# ADA Compliance Program

## Tri-Mountain Golf Course – Accessibility Survey 1701 NW 299<sup>th</sup> Street - Ridgefield, WA

Date of Survey: July 7, 2008  
 Conducted by: Trenton Hanson, Wayne Yarnall, Bud Van Cleve, Dave Maret, Tim McVicker

Fig. 503.3  
Passenger Loading Zone Access Aisle

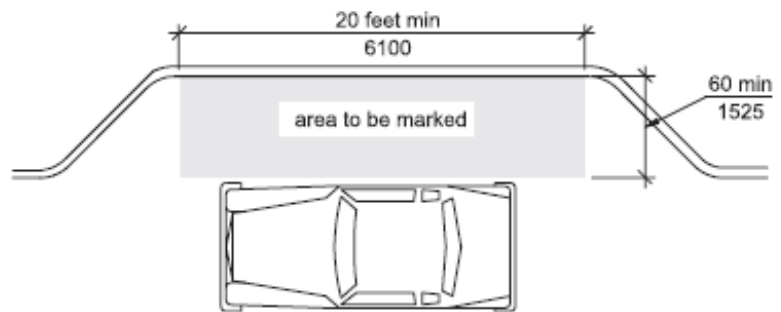
Item # 5  
Issue: Passenger Loading Zone Access Aisle and Curb Cut  
Issue:  
Location: North side of Club House  
Code: ANSI 503.2 Vehicle Pull-up Space Size. Passenger loading zones shall provide a vehicular pull-up space 96 inches (2440 mm) minimum in width and 20 feet (6100 mm) minimum in length. – See diagram below.

Notes: The main entrance to the club house has what appears to be a pull-up area for passenger loading and unloading. If this is the purpose of the pull-up it must meet the accessible standards listed in this section of the survey. Additionally, a curb cut, with truncated domes, will be required from the

<p>drop-off area to the front or north door of the club house. <u><i>If this is not a drop-off zone, it should be signed as such.</i></u></p>
<p>No Photo</p>	<p>Item # 6</p> <p>Issue: Existing Accessible Curb Cut (Ramp) No Detectible Warning Lip Exceeds ½ inch Maximum Height</p> <p>Issue: Front of Club House</p> <p>Location:</p> <p>Code: ANSI 303.2 Vertical - Changes in level of ¼ inch (6.4 mm) maximum in height shall be permitted to be vertical. ANSI 303.3 Beveled - Changes in level greater than ¼ inch (6.4 mm) in height and not more than ½ inch (13 mm) maximum in height shall be beveled with a slope not steeper than 1:2. IBC- Section 1102 Definitions – Detectable Warnings – A standardized surface feature built in or applied to walking surfaces or other elements to warn visually impaired persons of hazards on a circulation path. ANSI Code: 705.2 Standardization – Detectable warning surfaces shall be standard within a building, facility, site or complex of buildings ANSI 705.5 Truncated Domes – Detectable warning surfaces shall have truncated domes complying with Section 705.5 (See preceding photo and comments)</p> <p>Notes:</p>

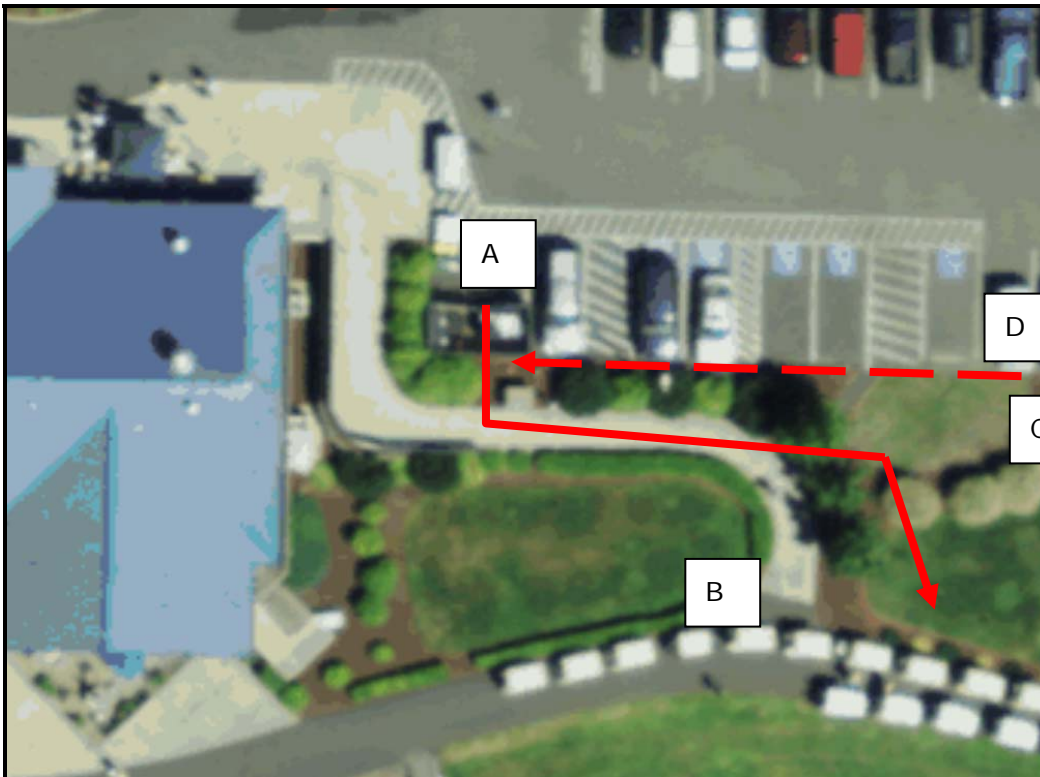
Cross slope measurements of parking area and ramps leading to parking area: (Running slopes cannot exceed 8%; cross slopes cannot exceed 2%)

Cross Slope - West parking lot area: 4.2%

Cross Slope- North parking lot area: 2.2%

Cross Slope - East parking lot area: 3.5%

Running Slope - Small paved ramp to parking area: 13.4%;

Cross Slope – Ramp: 2.9%

Cross Slope - Sidewalk approaching above listed ramp: 3.8%

Running Slope - Paved ramp west of clubhouse north of cyclone fence: 19.3%

Recommendations: The west side golf cart area is inaccessible. An alternate location needs to be identified where:

**Point A** – Provide signage for accessible path. (Signage for accessible routes is currently non-existent) Signage will be located at end of recommended ramp for parking as shown above in “Parking and Passenger Loading Zone” section of this report.

**Point B** – Excavate into bank. Construct retaining wall; pave area for accessible golf cart parking. Meet required slope requirements.

**Point C** – Remove gravel path or provide signage to accessible pathway.

**Point D** – The accessible path will intersect with the proposed parking access aisle.

**Fig. 604.5.1**  
**Side Wall Grab Bar for Water Closet**

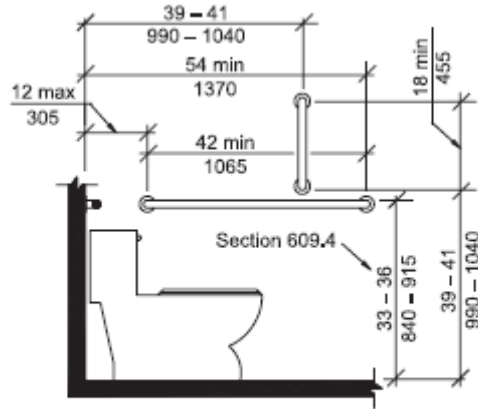
Issue: Flush Controls

Issue: Vertical Grab Bars

Code: ANSI 604.10.6 Flush Controls - Flush controls shall be hand operated or automatic. Hand operated flush controls shall comply with Sections 309.2 and 309.4 and shall be installed 36 inches (915 mm) maximum above the floor. Flush controls shall be located on the open side of the water closet.

ANSI 604.5.1 – Vertical Grab Bar

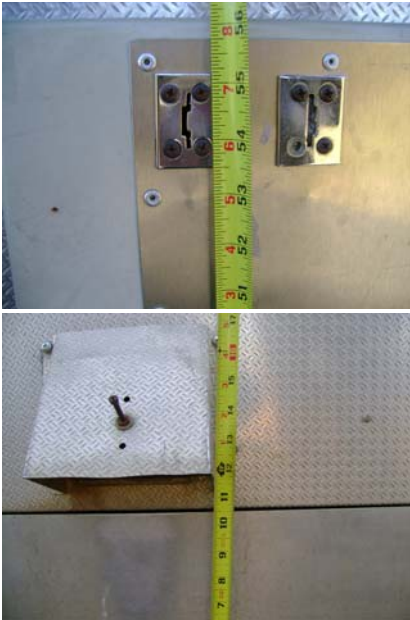
<p>Item # 30</p> <p>Issue: Accessible Benches</p> <p>Issue:</p> <p>Location: Throughout Course</p> <p>Code: ANSI 903.1 General. Accessible benches shall comply with Section 903.</p> <p>ANBSI 903.2 Clear Floor Space. A clear floor space complying with Section 305, positioned for parallel approach to an end of the bench seat, shall be</p>
---	--

<p>provided.</p> <p>ANSI 903.3 Size. Benches shall have seats 42 inches (1065 mm) minimum in length, and 20 inches (510 mm) minimum and 24 inches (610 mm) maximum in depth.</p> <p>ANSI 903.4 Back Support. The bench shall provide for back support or shall be affixed to a wall. Back support shall be 42 inches (1065 mm) minimum in length and shall extend from a point 2 inches (51mm) maximum above the seat surface to a point 18 inches (455 mm) minimum above the seat surface. Back support shall be 21/2 inches (64 mm) maximum from the rear edge of the seat measured horizontally.</p> <p>ANSI 903.5 Height. The top of the bench seat shall be 17 inches (430 mm) minimum and 19 inches (485 mm) maximum above the floor, measured to the top of the seat.</p> <p>ANSI 903.6 Structural Strength. Allowable stresses shall not be exceeded for materials used where a vertical or horizontal force of 250 pounds (1112 N) is applied at any point on the seat, fastener mounting device, or supporting structure.</p> <p>ANSI 903.7 Wet Locations. Where provided in wet locations the surface of the seat shall be slip resistant and shall not accumulate water.</p> <p>Notes: All benches within the complex should be examined for accessibility</p>
